Technical Service Bulletin

Number: 23-23-99

Rear Door Glass Will Not Roll Down All The Way

2000 (PL) Neon

FIGURE 1

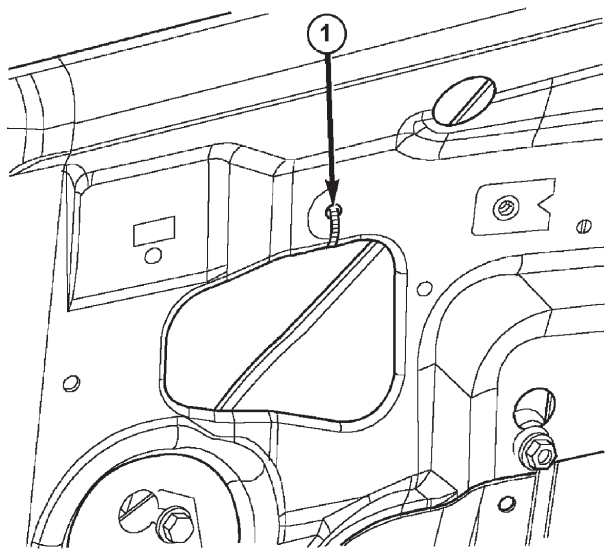
1. Remove the rear door trim panel and partial watershield to access the conduit clip using the procedure in the 2000 Neon Service Manual (publication No. 81-270-0025) 23-40.
2. Roll the rear door side window to the full up position.
3. Remove the conduit clip from the regulator conduit and discard (Figure 1).

1-	Access Hole
2-	Conduit Cable Clip Attaching Hole
3-	Conduit Cable Clip

FIGURE 3

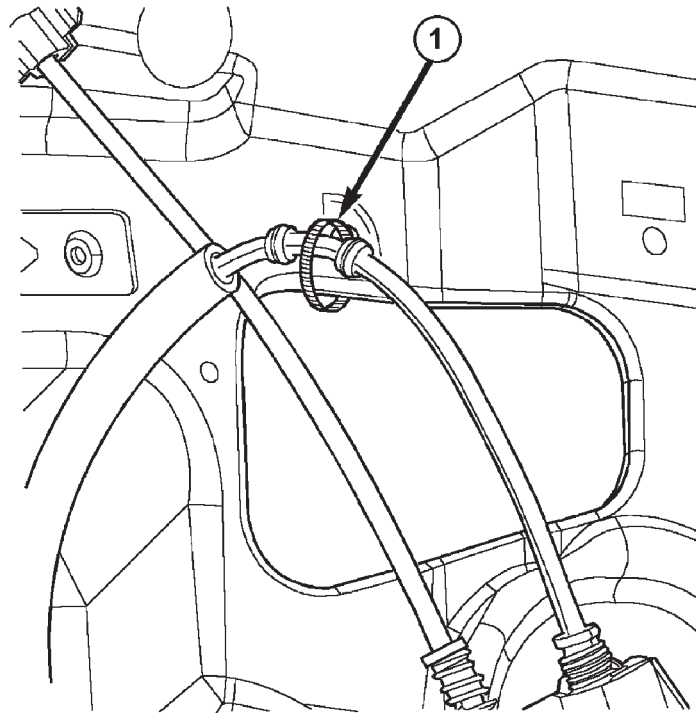
- 4. Route plastic tie strap through conduit attaching hole, around conduit and back through access hole to securely fasten conduit to door inner panel (Figures 2 & 3).

1-	Plastic Tie Strap
----	-------------------

- 5. Trim excess tie strap.
- 6. Roll the window all the way down and all the way up to verify interference and binding have been eliminated.
- 7. Install door watershield and trim panel.
